# Airstream Inc.

06V-161  
(11 Pages)

**Bulletin Number: 140**  
**Product Line: 2005, 2006 16' Safari Bambi**  
**Subject: 110-Volt Galley Receptacle Replacement**  
**Attn.: Owner, General Mgr, Service Mgr**

### GFCI Receptacle Installation Instructions

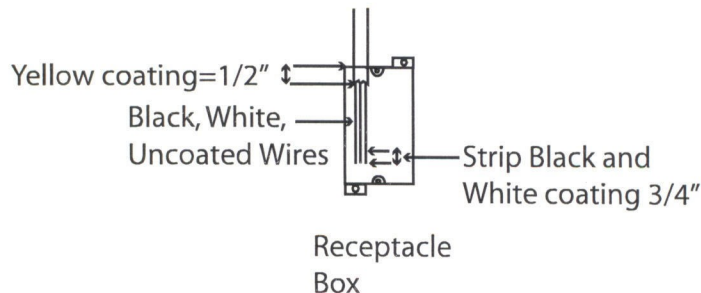
**Problem:** A GFCI receptacle is required above the galley on the 16' Safari Bambi model per Nation Electrical Codes. A standard 110-volt receptacle was installed on the units listed in this bulletin.

**Solution:** Replace the standard 110-volt receptacle above the galley with a 110- volt GFCI protected receptacle. This repair pertains to the 2005 and 2006 16' Safari Bambis listed in this bulletin only.

1. Making sure masking tape is in place as explained earlier, trim edges of receptacle hole to a rectangular hole measuring 2 3/8" Wide x 3 5/8" High. This is the hole size specified for the new plastic receptacle box.
2. Strip approximately 3" of the yellow insulating coating from the wire. Be careful not to damage the coating on the individual wires inside the yellow coating. Strip approximately 3/4 inch of the coating from the exposed black and the white wires.
3. Pull the wires through the tabbed hole in the plastic box. Be careful not to break off the tab, it serves as a strain relief for the wires. Pull enough wire through the tabbed hole so that 1/2 inch minimum of yellow coating extends into box.

4. Center the box in the hole and using a #30 drill bit, drill two holes in the skin. Use the holes in the box for a guide. Fasten plastic receptacle box to interior skin using the two AD 45 pop rivets provided in the parts kit. See receptacle box diagram.
